**PLANNED UNIT DEVELOPMENT  
STAFF REPORT****Date: November 1, 2012****DEVELOPMENT NAME**

DAA Acquisitions of Alabama

**LOCATION**3030 McVay Drive North  
(East side of McVay Drive North, 2/10± mile South of U.S.  
Highway 90).**CITY COUNCIL  
DISTRICT**

**CONTEMPLATED USE**Planned Unit Development Approval to amend a  
previously approved Planned Unit Development to allow a  
reduction in the front landscaping requirements.**TIME SCHEDULE  
FOR DEVELOPMENT**

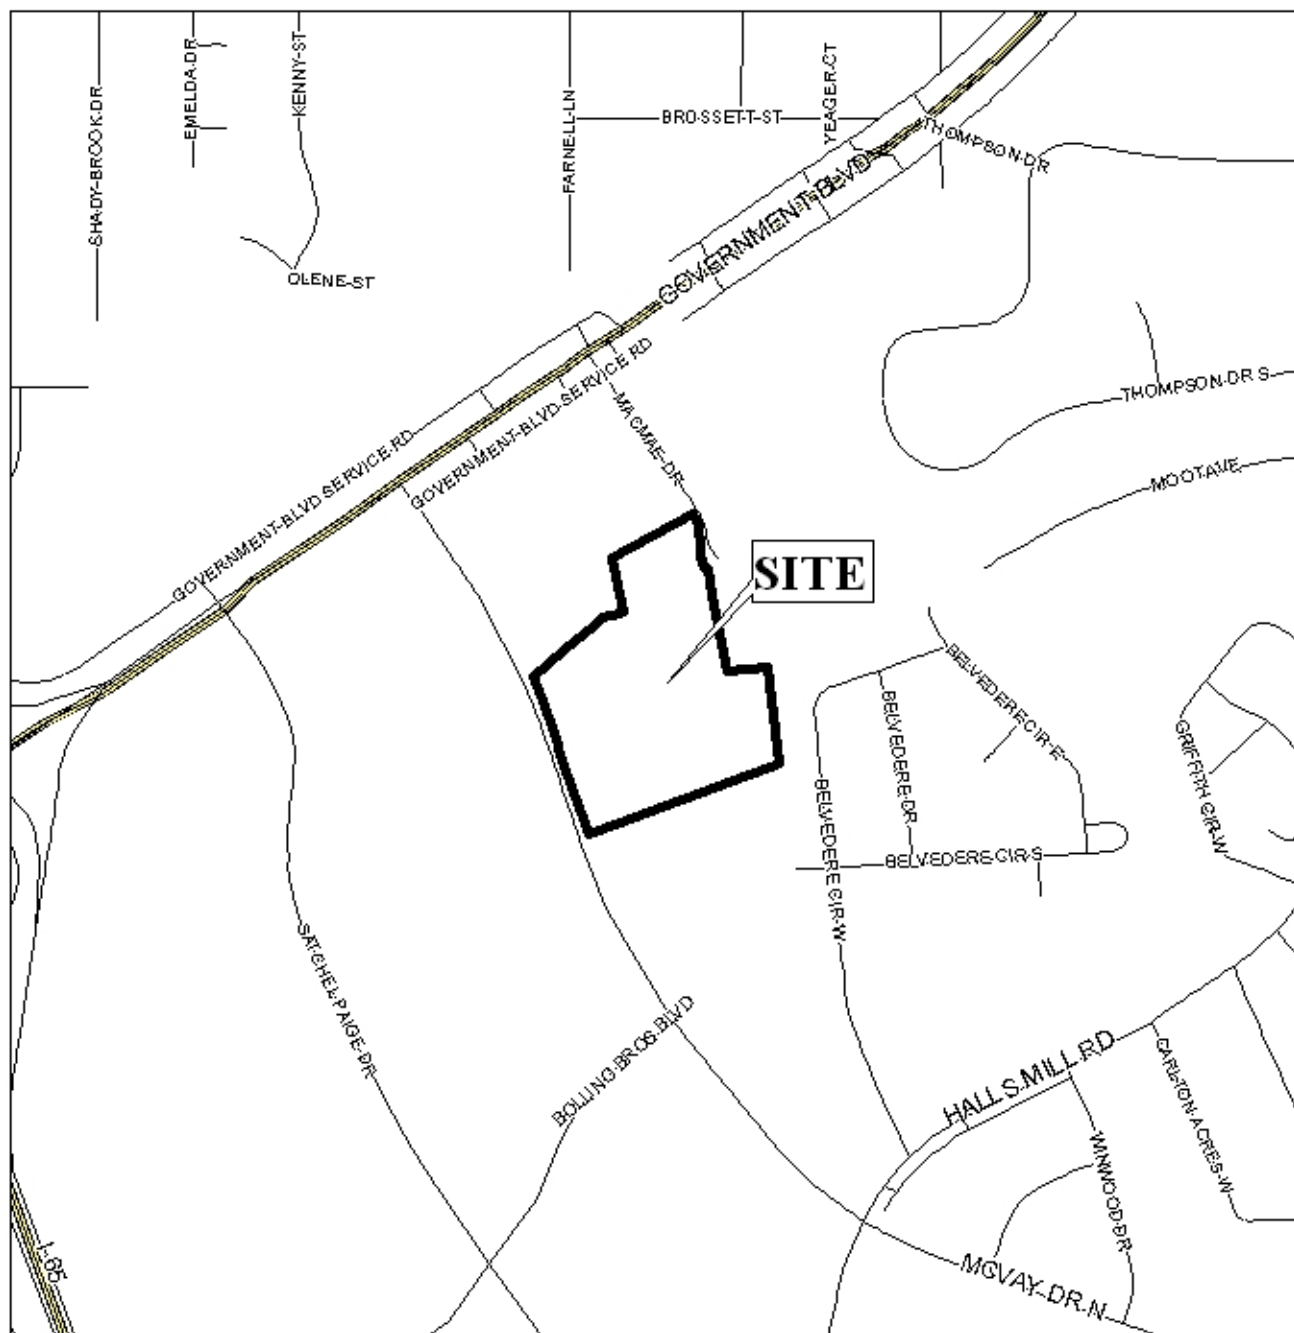
It should be noted that the site plan does not incorporate two conditions of approval of the previous PUD. One required placement of a note on the site plan stating that the placement of

additional dumpsters on the site will require a new PUD submittal. The other required compliance with the Traffic Engineering comments: *“Driveway on McMae Drive should be limited to 24’ wide. Radii for McMae Drive driveway are not illustrated on the site plan. A 20’ radius is typical for passenger cars and a 30’ radius is desirable for large trucks”*. Neither the dumpster note nor the revision of the McMae Drive driveway to a 24’ width is indicated.
